September 22, 2009

Re: Request for EPA Consideration in Feasibility Study of Additional Pond Sediment Remedial Alternative - Centredale Manor Restoration Project Superfund Site, North Providence, Rhode Island

CENTREDALE MANOR RESTORATION PROJECT

Comm.No.		
15RP601	**FIGURE 1**	LEA

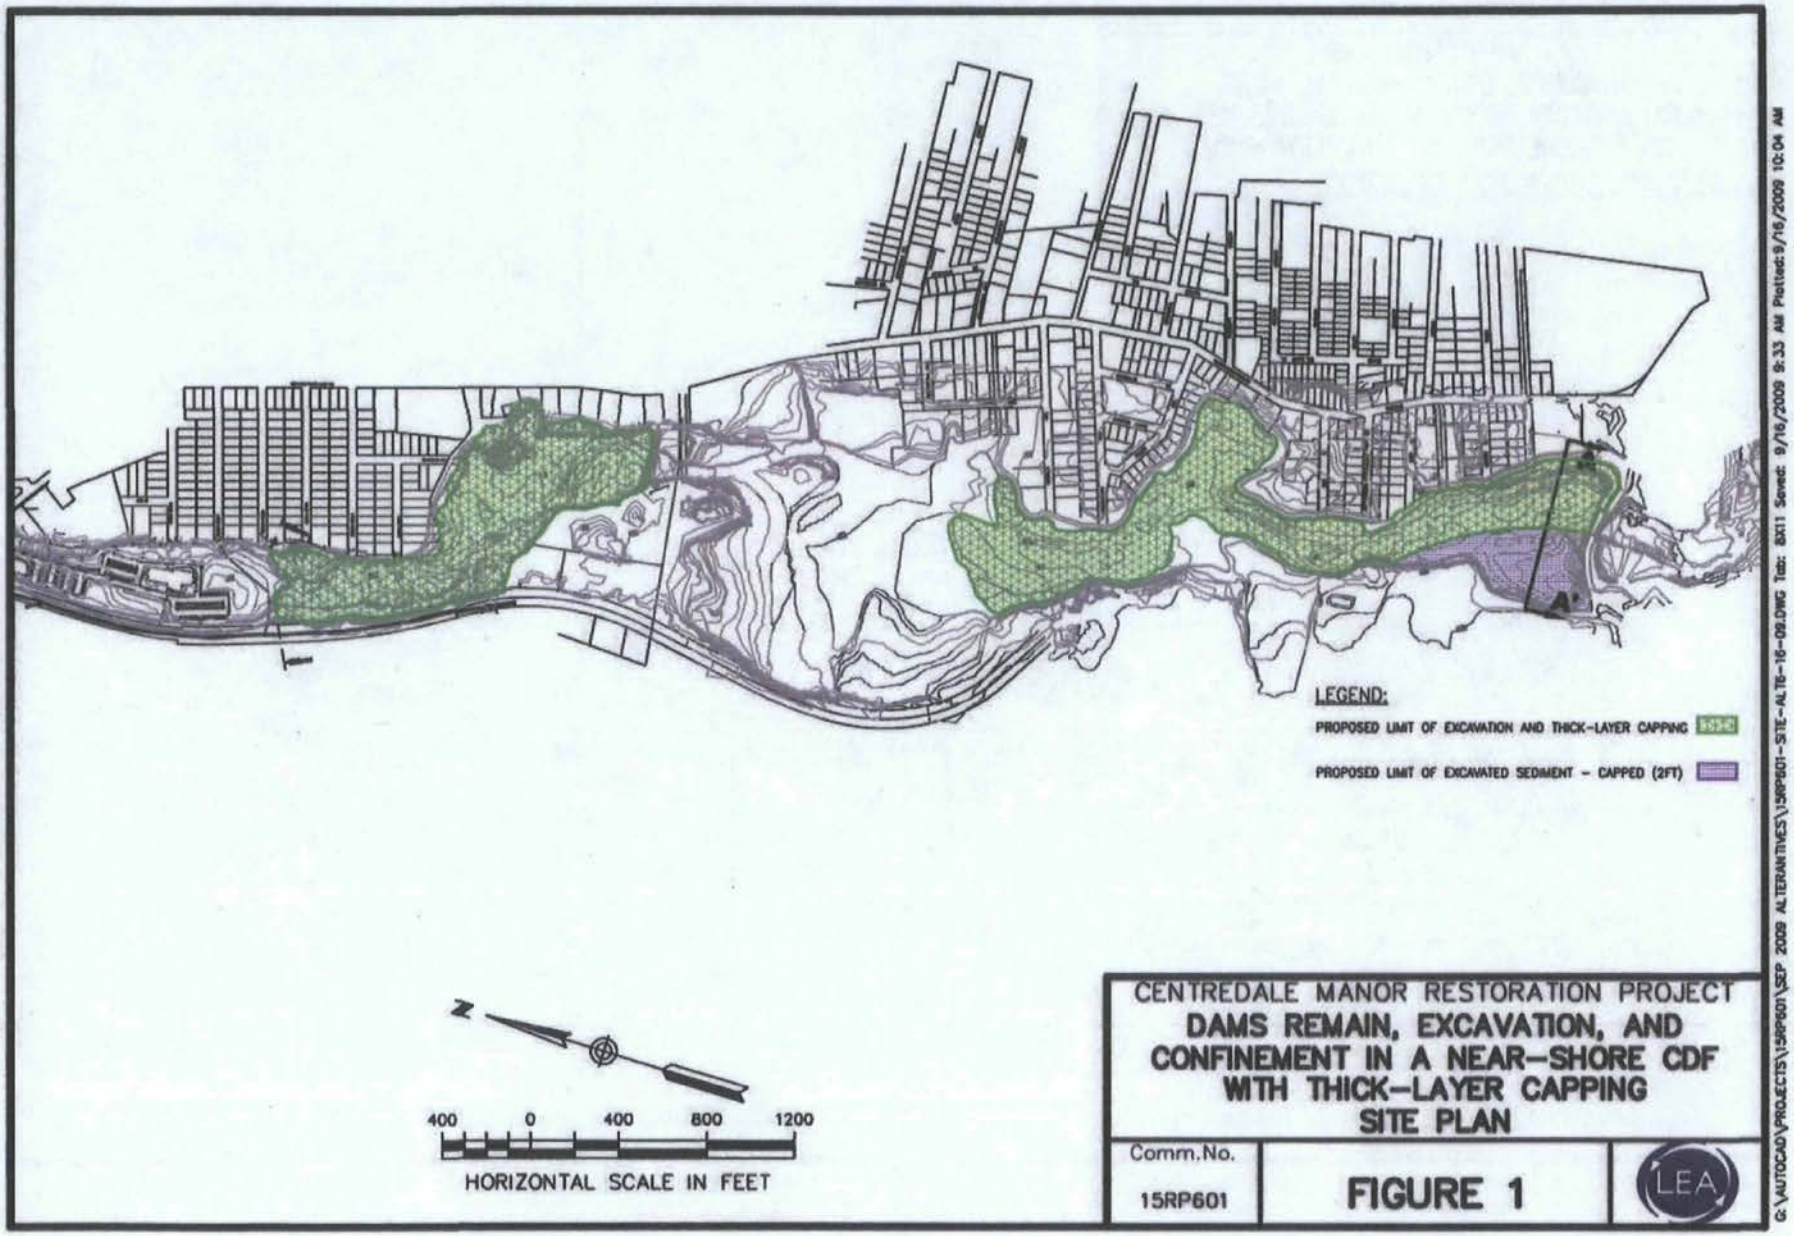
In light of the foregoing, Emhart requests that USEPA consider in the Feasibility Study an additional remedial alternative under which sediments containing dioxin/furans that exceed 1 ppb would be excavated and placed in an approximately five acre near-shore CDF along the west bank of Lyman Mill Pond. Sediment that is not excavated would be capped *in-situ*. The sediments to be placed in a near-shore CDF would be excavated in the manner described in USEPA's Alternative 7(b), *Excavation and Confinement in an On-site Near-Shore CDF* (USEPA Draft Feasibility Study Report). Up to 50% of the more contaminated sediments within Allendale Pond would be excavated. These sediments, identified by USEPA using the data obtained during the Remedial Investigation, would be excavated to an average depth of approximately two feet, resulting in the excavation of up to approximately 30,000 cubic yards of sediment. The excavated sediments would be placed in the near-shore CDF.

The proposed location of the near-shore CDF along the west bank of Lyman Mill Pond is shown in Figure 1, and a schematic of the proposed near-shore CDF is shown in the cross section provided in Figure 2. After the excavated sediments are placed in the near-shore CDF, a cover system would be installed consisting of an impermeable, flexible membrane liner, 20 inches of

Comm.No.		
15RP601	**FIGURE 2**	LEA

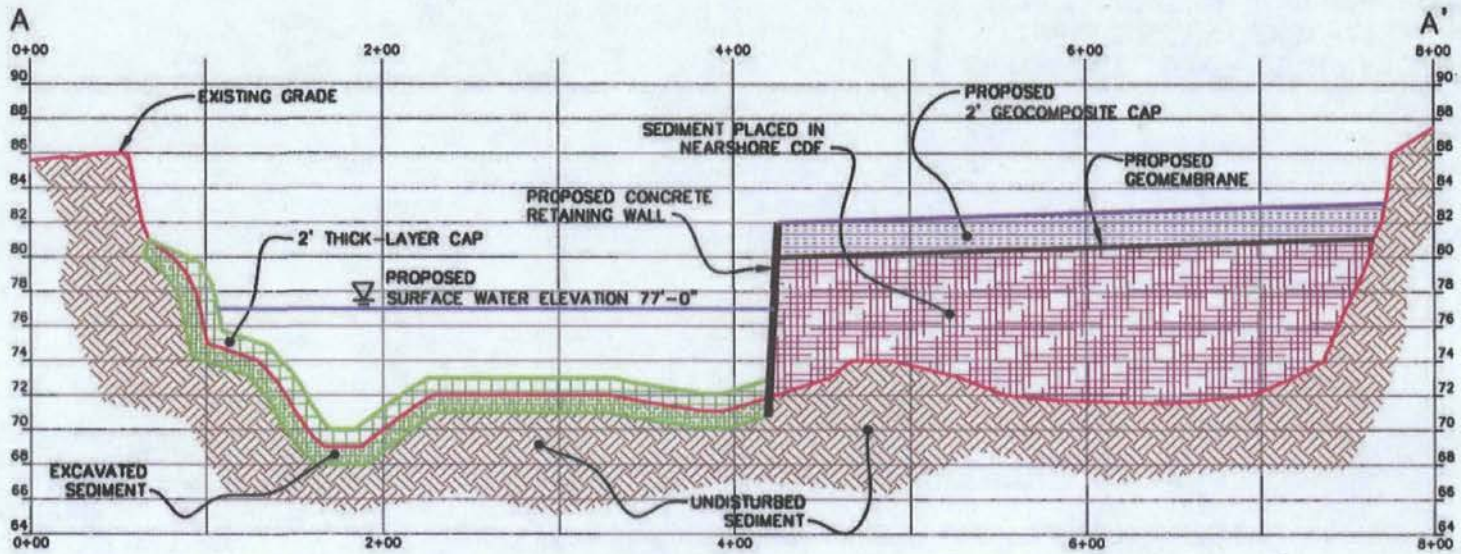
sand, and four inches of topsoil. The surface of the cover would be seeded to establish protective vegetation to provide for the long-term effectiveness of this disposal alternative.
